Consulting Party Comments RE: CityBridge/Boldyn 5G Network Tower at 1880 Broadway

SITE NAME: MN-07-GF0959_A

ADDRESS: 1880 Broadway

CONSULTING PARTY: LANDMARK WEST!

Figure 1. View towards proposed Link 5G tower, taken from the southwest corner of Broadway and 62nd Street . The Century Apartments can be viewed in the background on the northwest corner of Central Park West and West 62nd Street.

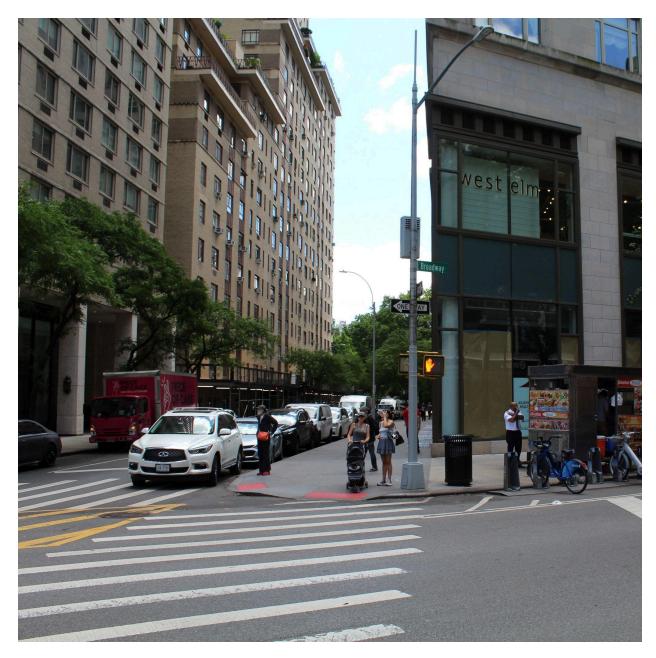
of Central Park West (CPW) Historic District on West 62nd Street. The proposed Link 5G tower will be in direct line of sight from the Century Apartments, within both Historic Districts, but also recognized on its own by the City as an individual landmark. Figure 6. in the provided information packet shows the close proximity of the 5G tower to the designated historic resource.

EBI says that "the proposed pole will not create a dominating visual element to the viewshed" of the district and the Individual Landmark. We disagree wholeheartedly. The enormous tower will affect the character of the landmarks, the streetscape and the character of the block which is contextual with the Historic District.

Figure 2. View towards the proposed 5G location from the boundary line of Central Park. The Century Apartments are on the right of the image. The approximate location of the proposed 5G location is highlighted by a red arrow. Image taken via Cyclomedia Street View.

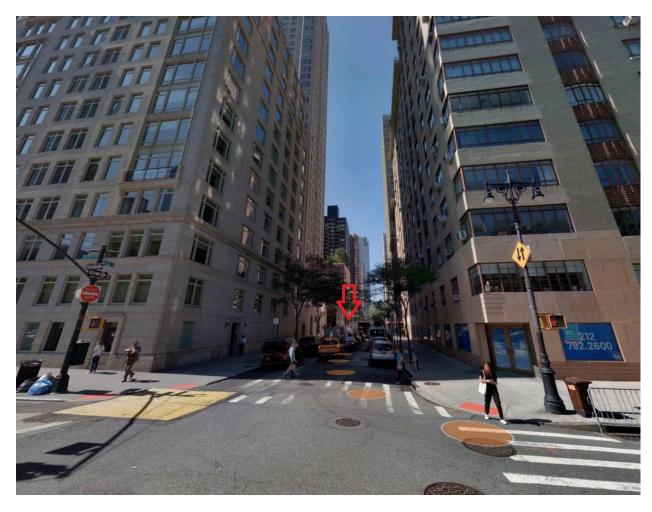
The proposed Link 5G tower is located 375 ft from the northwest of the western boundary line of Central Park, a national landmark. Central Park is on the National Register of Historic Places and is a National Historic Landmark. It is also locally designated by the Landmarks Preservation Commission as a Scenic Landmark. Central Park is listed on the NRHP under criteria C for its outstanding contribution to landscape architecture. Central Park was created as a refuge for the people of New York City living in a dense urban environment. It enabled all city dwellers to enjoy the beauty and recreational benefits of a Victorian-era public park. It was the first large-scale, public park in the nation that was designed and constructed according to a plan, by master architects Frederick Law Olmsted and Calvert Vaux.

The parks' design and characteristics are not contained within the park itself. Its character defining features extend past the park onto the sidewalk and the street lamps, and onto the

quiet blocks of Central Park West and its side streets. The proposed pole is located within visual APE of Central Park. A viewshed analysis was not performed in this case, however, Figures 2. & 6. in the information packet provided shows the close proximity of the tower to the resource and its potentially adverse visual effect. We believe the placement of the Link 5G tower at this location will significantly impact the irreplaceable landmark that is Central Park.
